Re: Addendum #1 – UNC Charlotte – Kenndy Hall Roof Replacement
SCO ID # 25-30579-01A

This addendum shall become part of the bidding package for Kenndy Hall Roof Replacement
SCO ID# 25-30579-01A

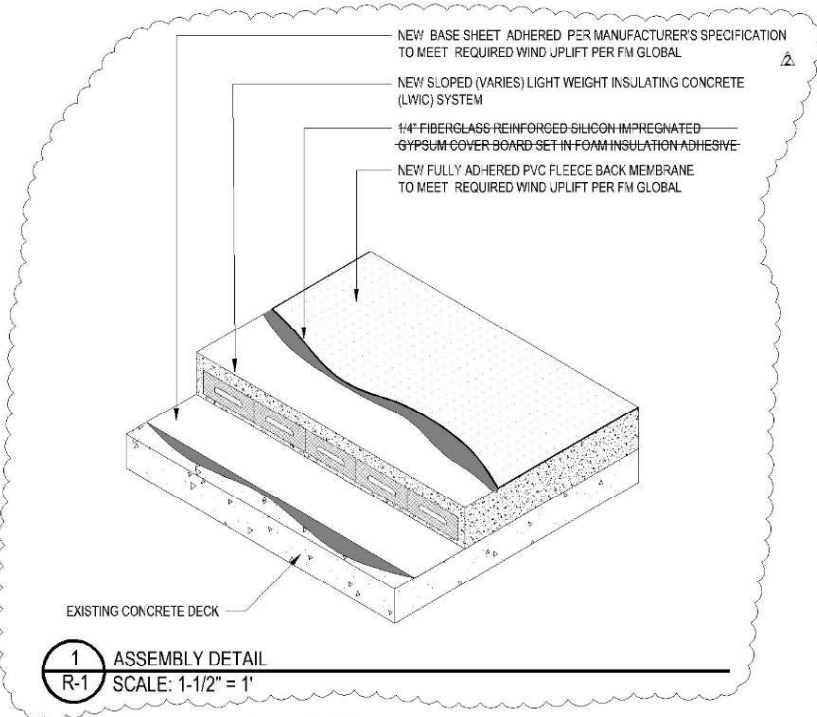
- A trash chute will be allowed location to chute will be coordinated with UNCC.

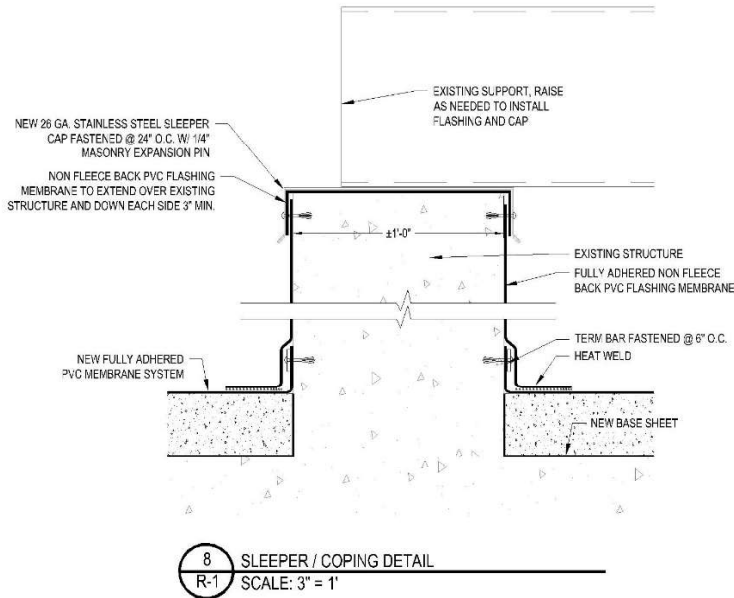
5. 1/4" fiberglass reinforced silicon impregnated gypsum cover board will not be installed over the light weight concrete.
